RE: DRAINAGE PLAN FOR INTERNATIONAL HOUSE OF PANCAKES
(L-22/D33D) REVISION DATED FEBRUARY 4, 1988

RE: DRAINAGE PLAN FOR INTERNATIONAL HOUSE OF PANCAKES
(L-22/D33D) ENGINEER'S STAMP DATED SEPTEMBER 22, 1987

Re: International House of Pancakes Site at Four Hills Village Shopping Center (L22)

FINAL GRADING & DRAINAGE PLAN

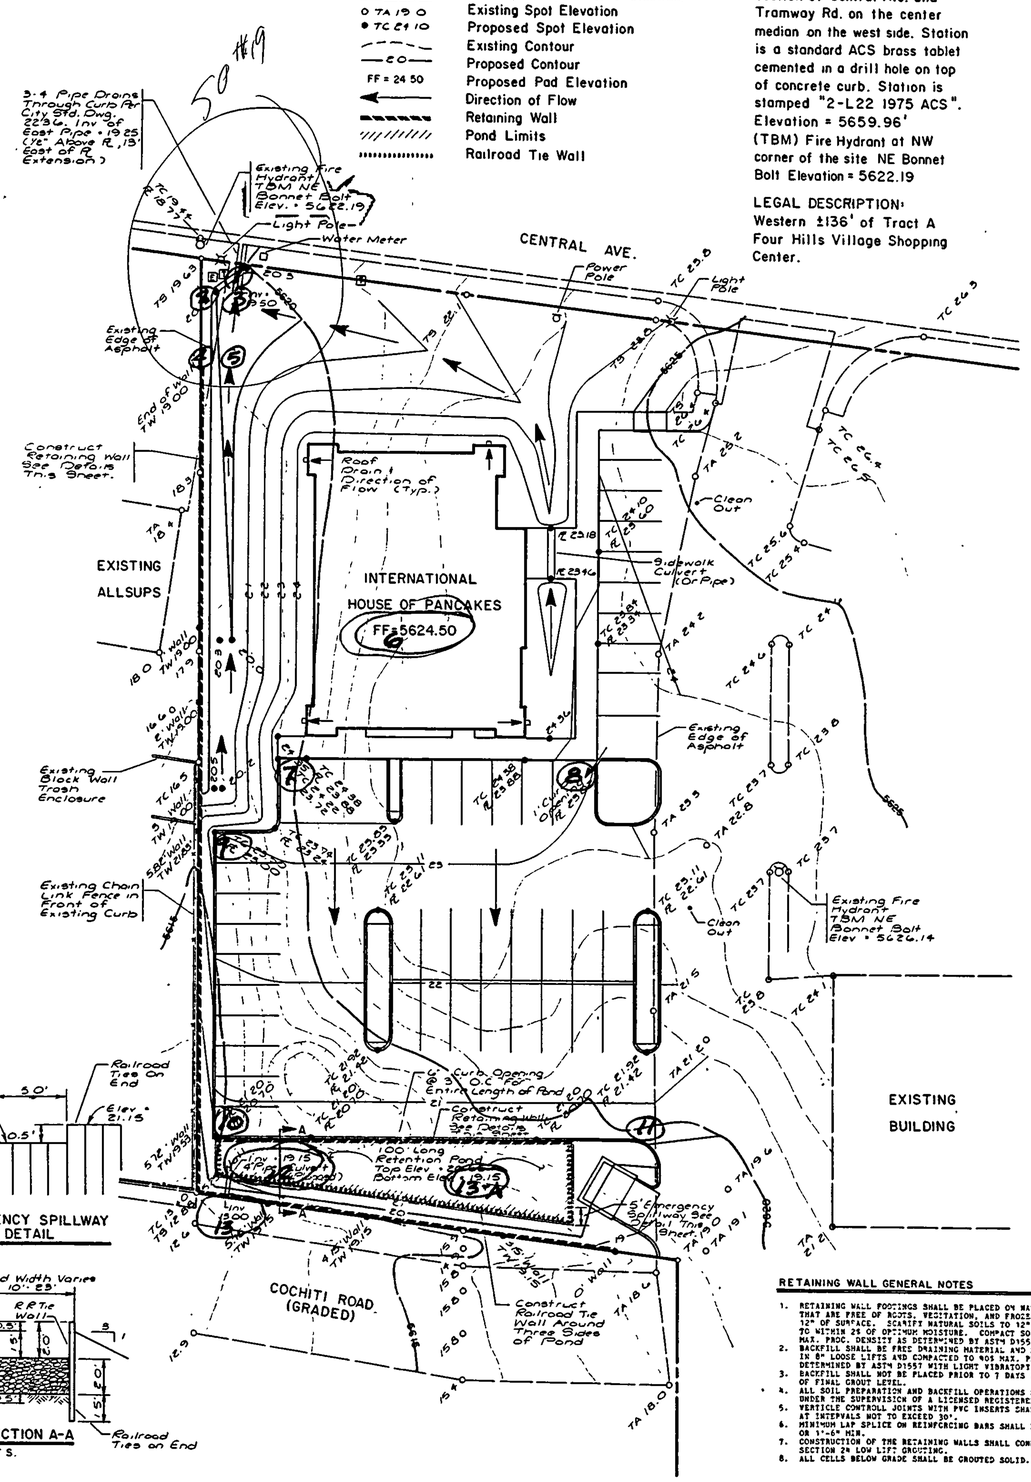
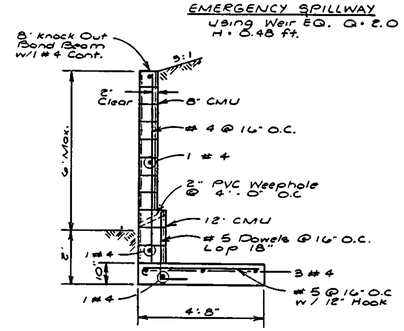
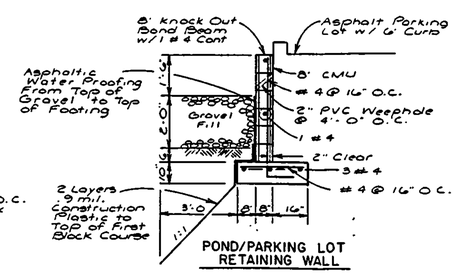
1. Finish floor elevation to full mean sea level designation.

2. Location and direction of roof drains.

3. Retain wall details.

4. S.O. #19 notes to contractor and sign-off block within the plan drawings.

5. How will erosion and sediment control be accomplished along proposed swales towards the outlet on Central?

6. Location of emergency spillway.

1. Finish floor elevation now shows full mean sea level designation.

2. Location and direction of roof drains are now shown.

3. Retaining wall details are now on the plan.

4. S.O. #19 notes and sign-off block have been added.

5. The landscaped area, which includes the swales that direct flow to the outlet on Central, will be irrigated grass.

6. The location of the emergency spillway is now shown.

13100 CENTRAL SE

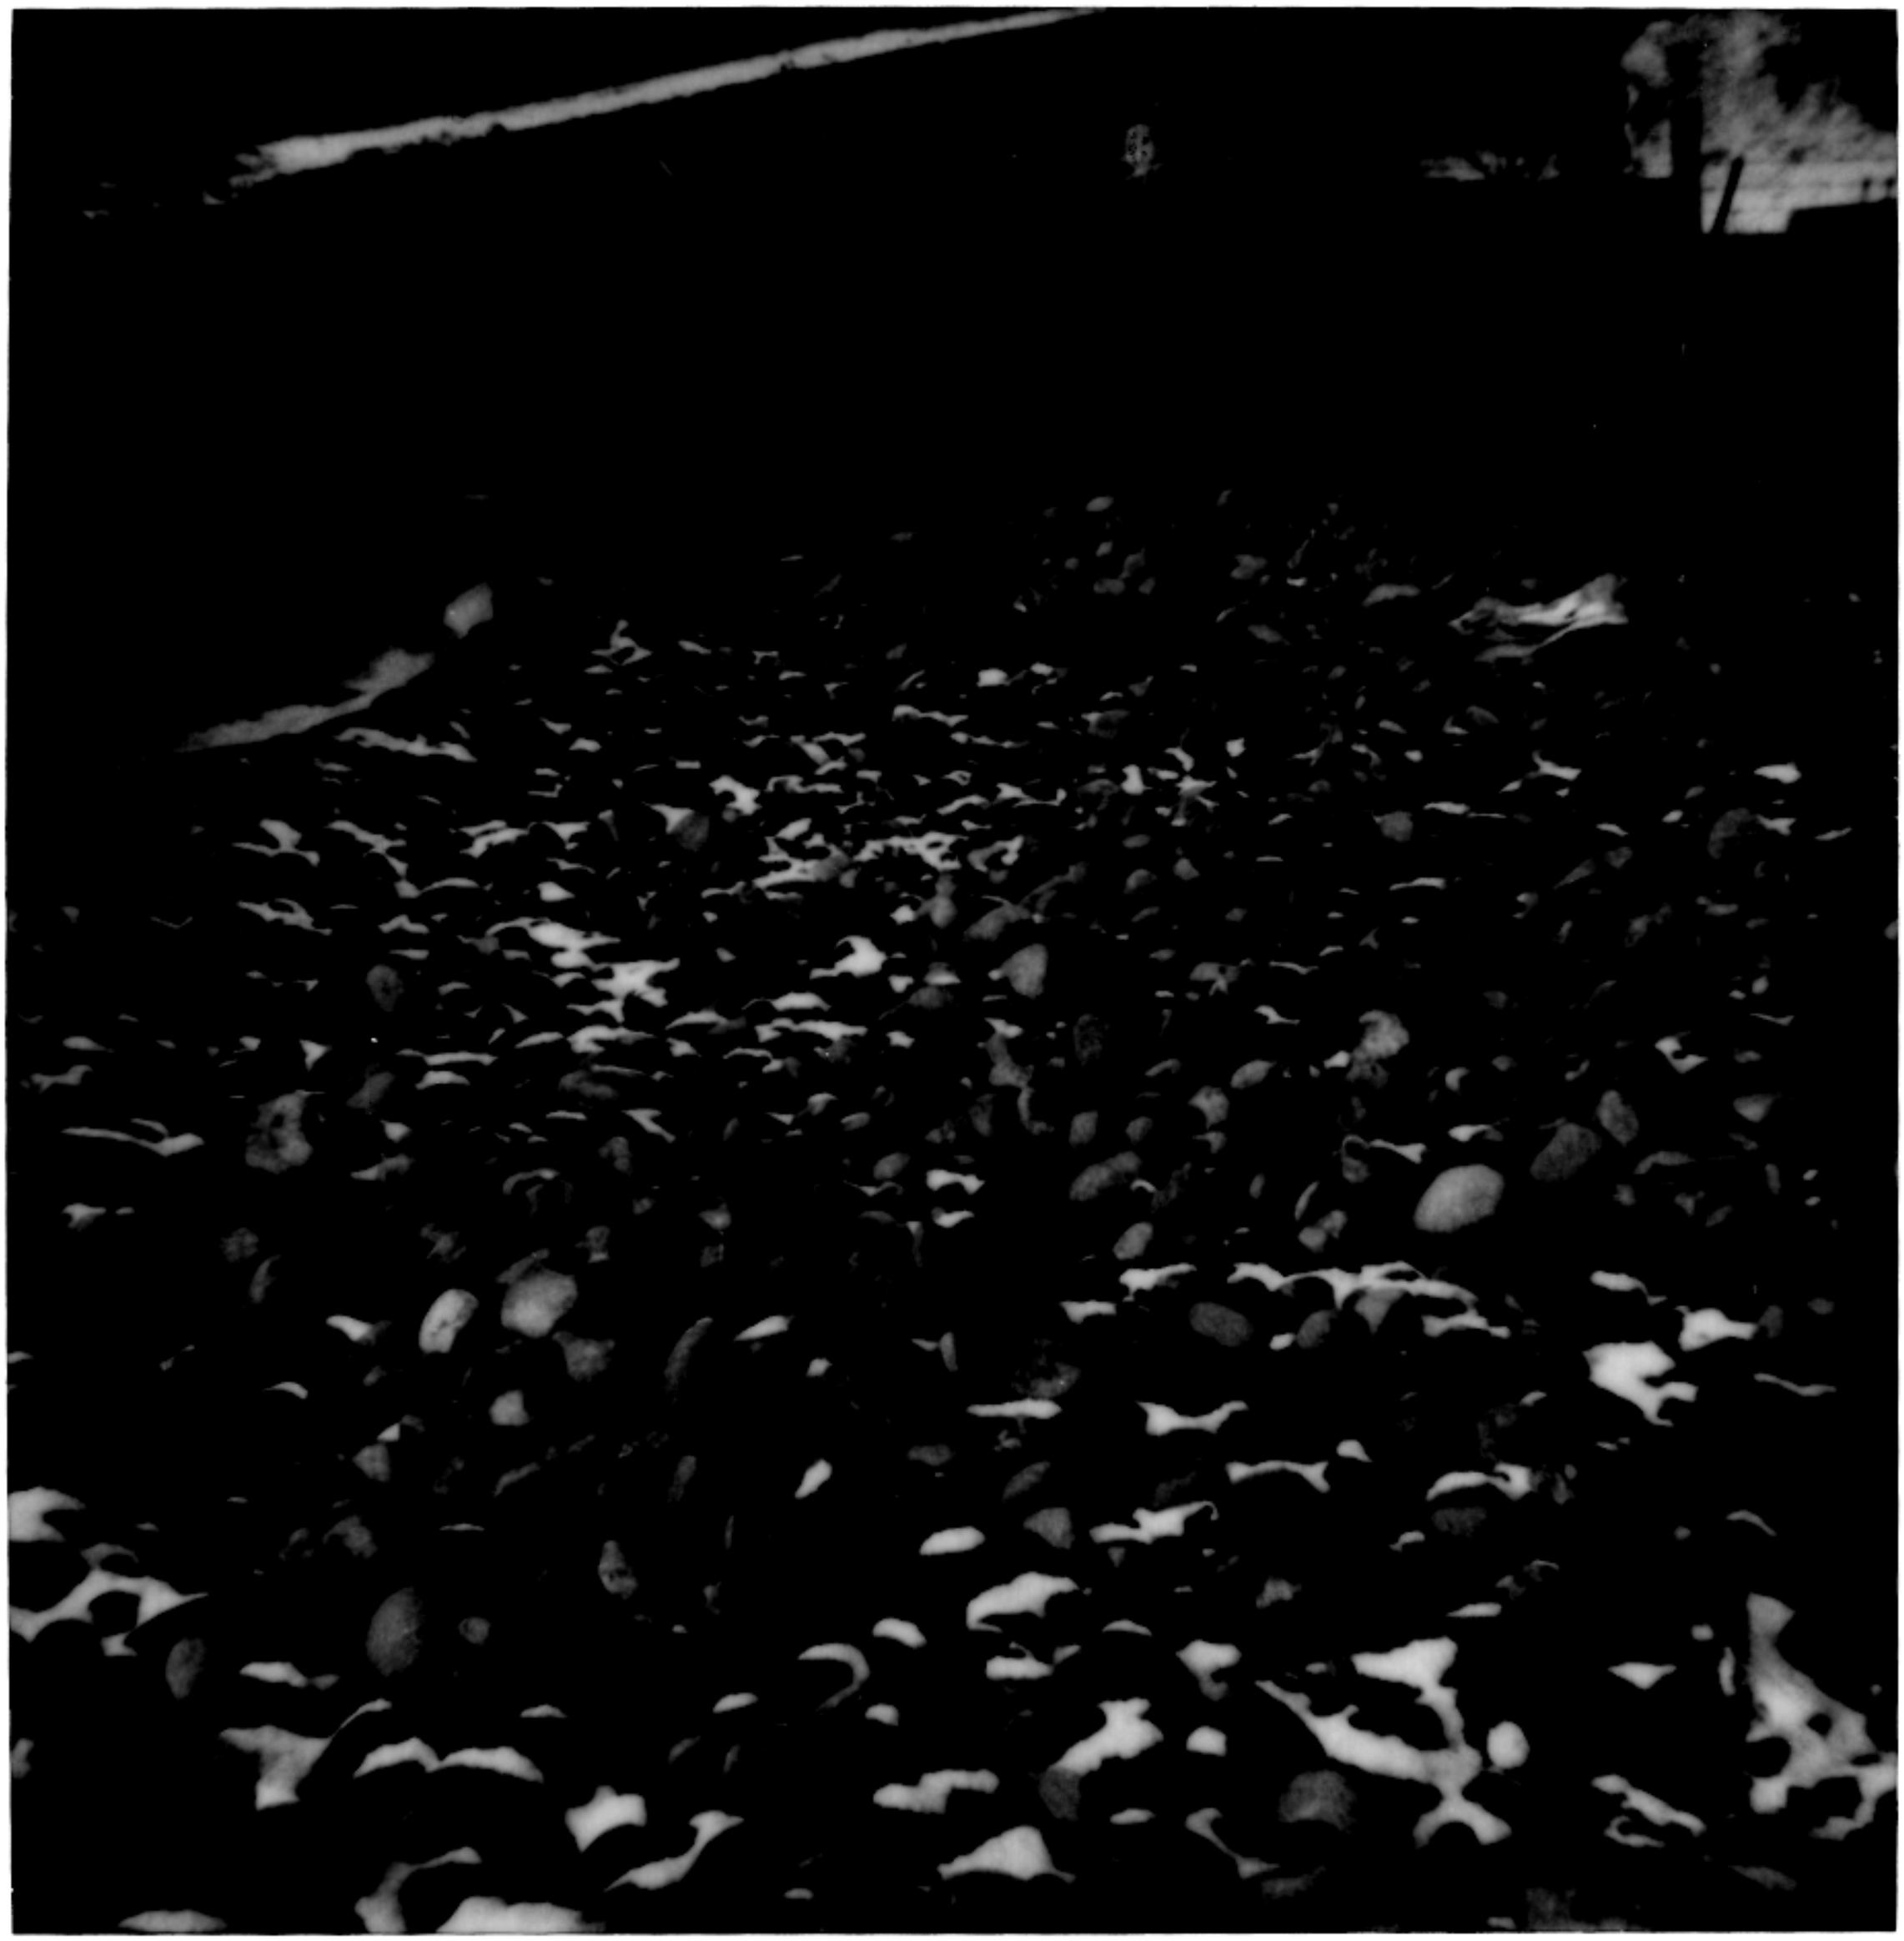
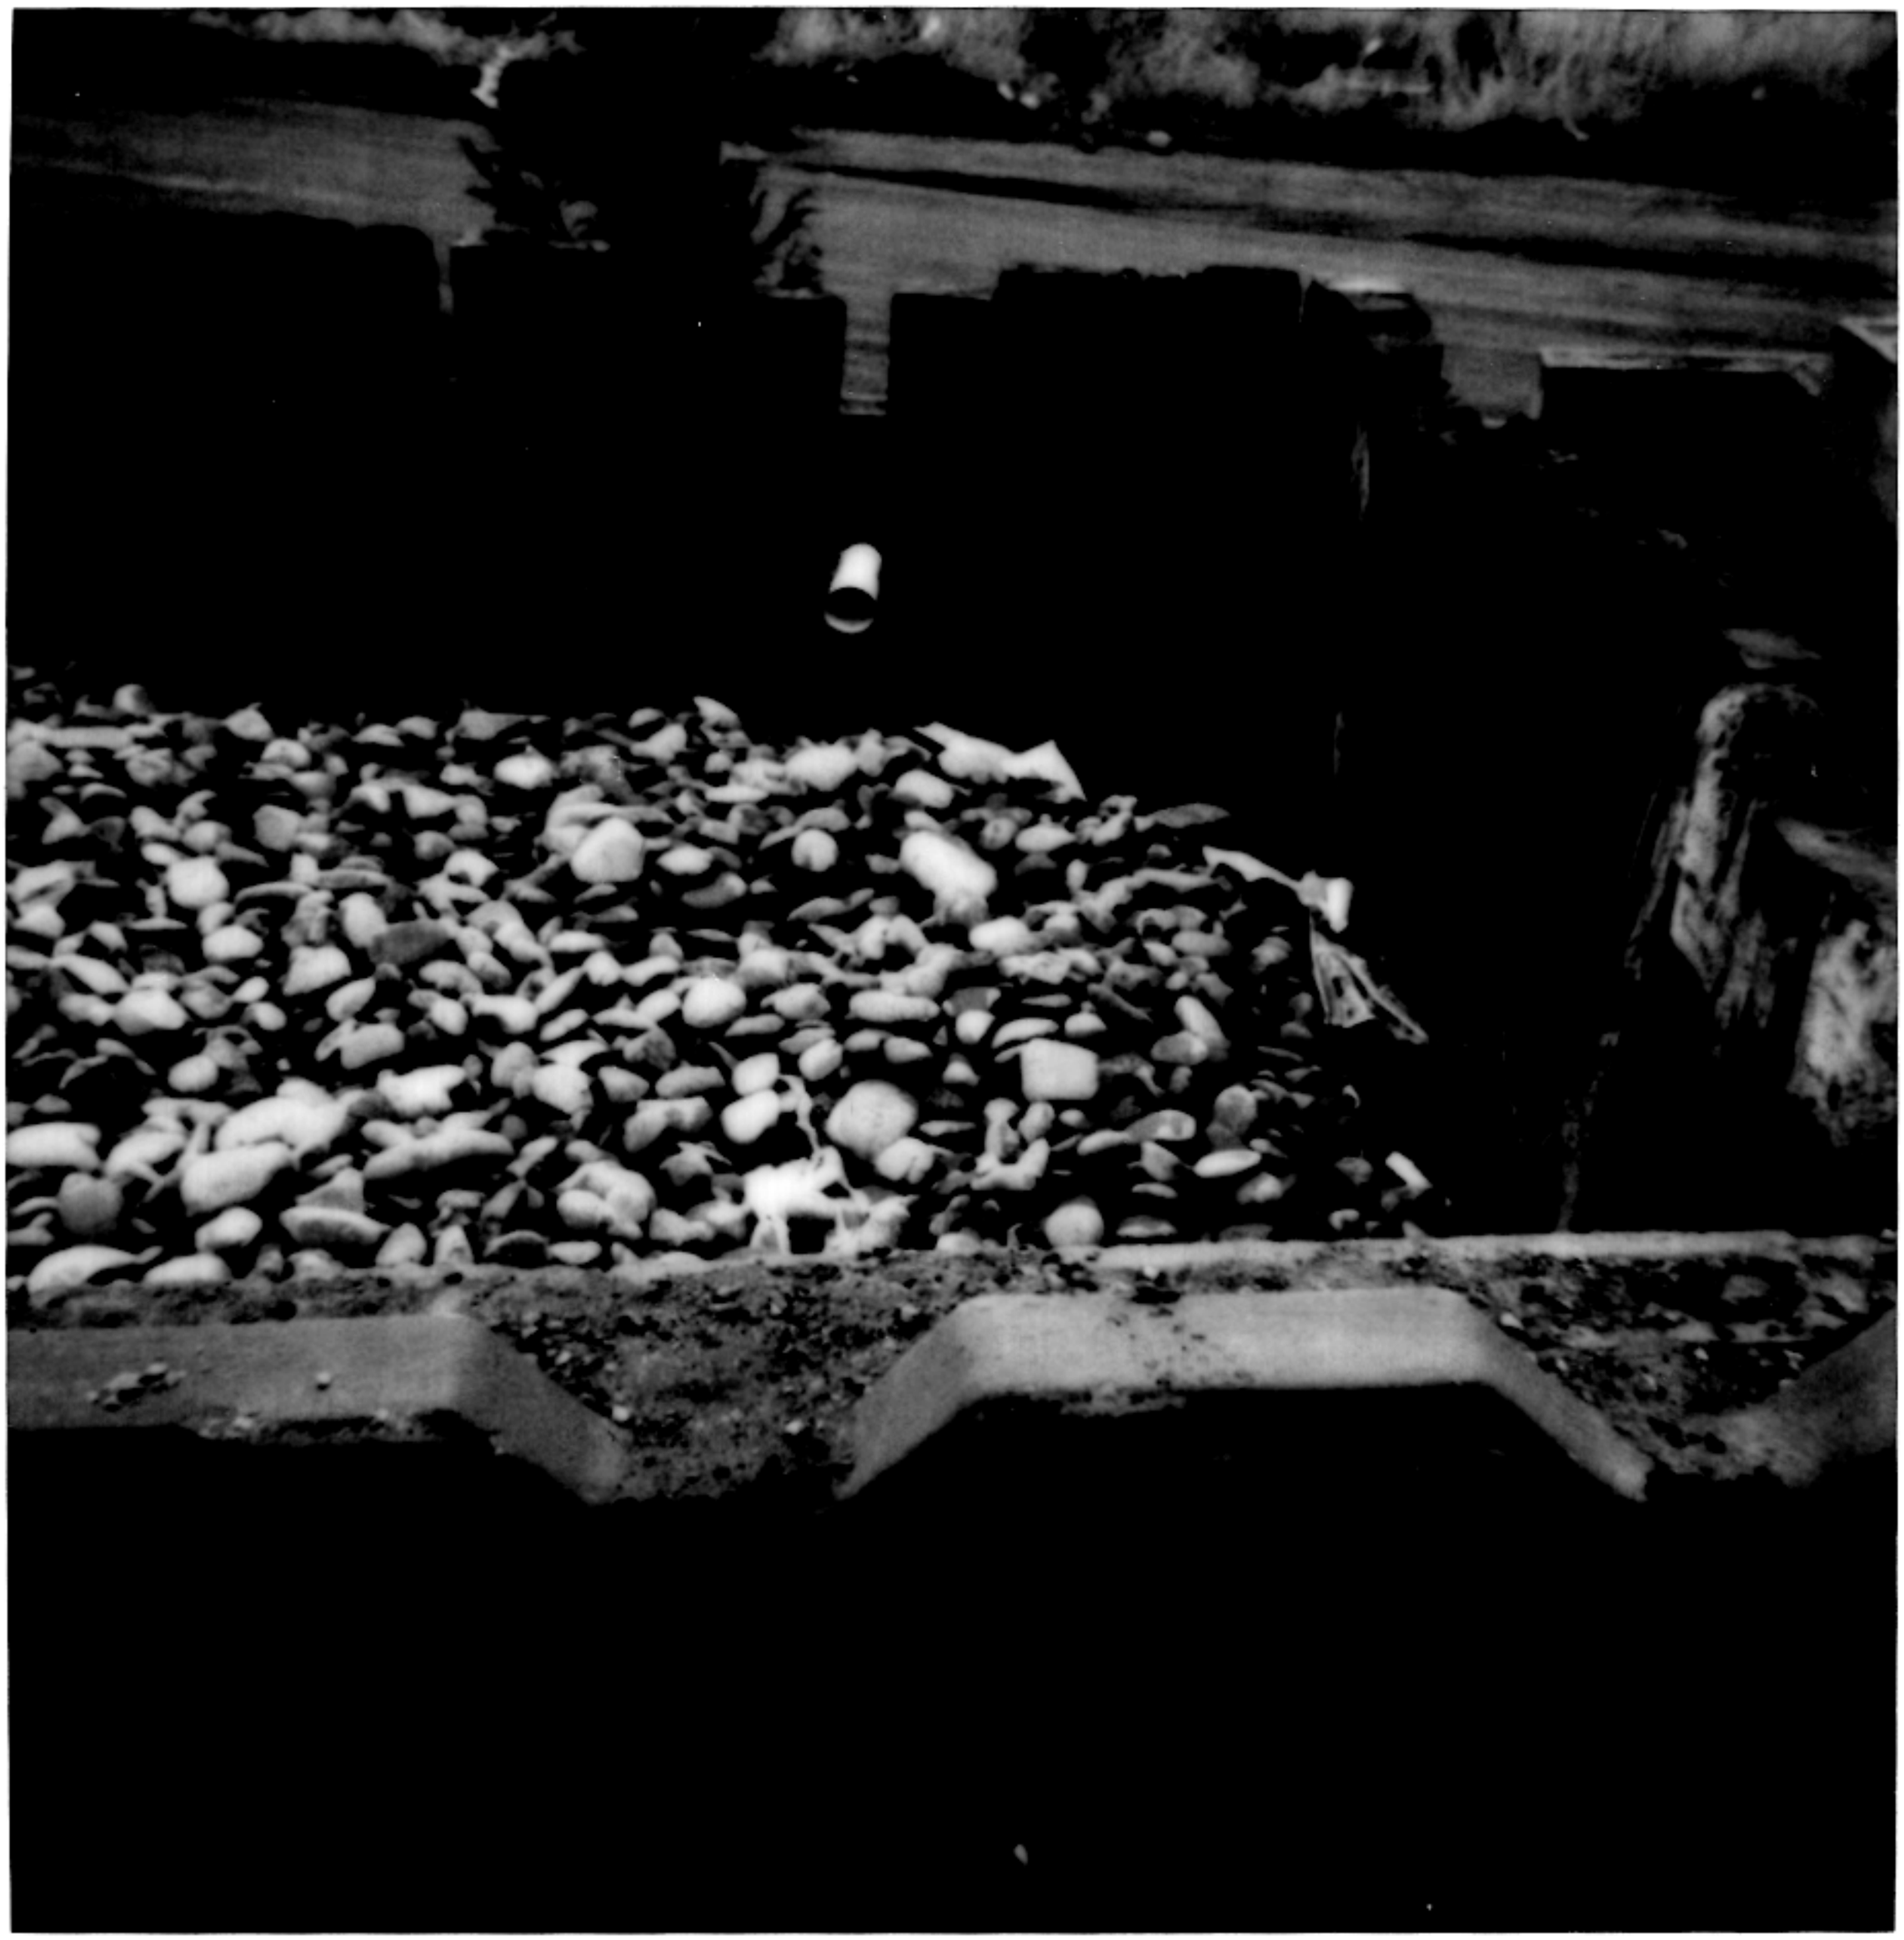
SINK @ N.W. CORNER MUST BE RE-WORKED.

POND OUTLET MUST BE REDONE PER B.L.M. & DAN GROCHOWSKI
